**NRC Audit at GE Office, San Jose, CA
June 5-8, 2006**

GE Status of Remaining Responses to RAI 3.7

Figure1.1 RB/FB model

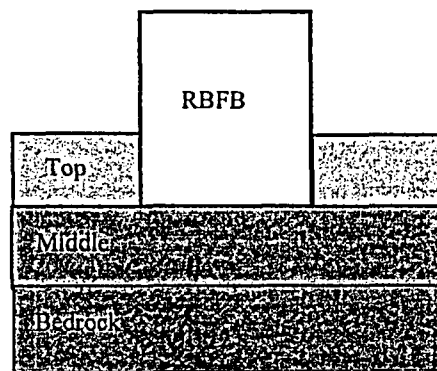
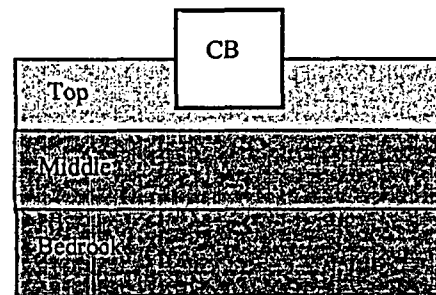
RAI Number	Question Summary	Full Text	Schedule	Status
3.7-57	<p>Demonstrate that the stick structural models developed based on the process described in the DCD can transmit frequencies up to 50 Hz and be able to capture the responses resulting from the high frequency components of North Anna input ground motions. (3.7.2)</p>	<p>DCD Tier 2, Section 3.7.2.3 indicates that the mathematical model of the structural system is constructed either as a stick model or a finite element model. These models are used in the soil-structure interaction (SSI) response analyses to determine seismic response of the soil structure system as indicated in DCD Section 3.7.2.4 and described in Appendix 3A to DCD Section 3.7. The free-field ground motions used as input to the plant analysis and design are described in DCD Section 3.7.1, and are ground motions that envelope either the RG 1.60 low frequency response spectrum or the high frequency ground motion developed for the North Anna early site permit site.</p> <p>DCD Figure 3.7-30 presents a plot of the North Anna design ground response spectrum and indicates a response spectrum that possesses its primary spectral accelerations in the frequency range from about 10 Hz to 50 Hz with a peak spectral acceleration at a frequency of about 20 Hz for the horizontal response spectrum and about 30 to 50 Hz for the vertical response spectrum. Appendix 3A to DCD Section 3.7 presents descriptions of the stick models developed for use in SSI analyses for the primary structures and internals of the plant. DCD Tables 3A.7-5 through 3A.7-14 present the results of eigenvalue analyses that are carried to frequencies as high as 27 Hz. These indicate participation factors of 0.28 at frequencies as high as about 25 Hz. The staff requests that the applicant demonstrate that the stick structural models developed based on the process described in the DCD can transmit frequencies up to 50 Hz and be able to capture the responses resulting from the high frequency components of North Anna input ground motions.</p>	8/18/06	<p>In progress. The CB stick model is being refined by adding additional mass points with the objective to show that the resulting responses are no more than 10% increase of the responses predicted from the original model.</p>
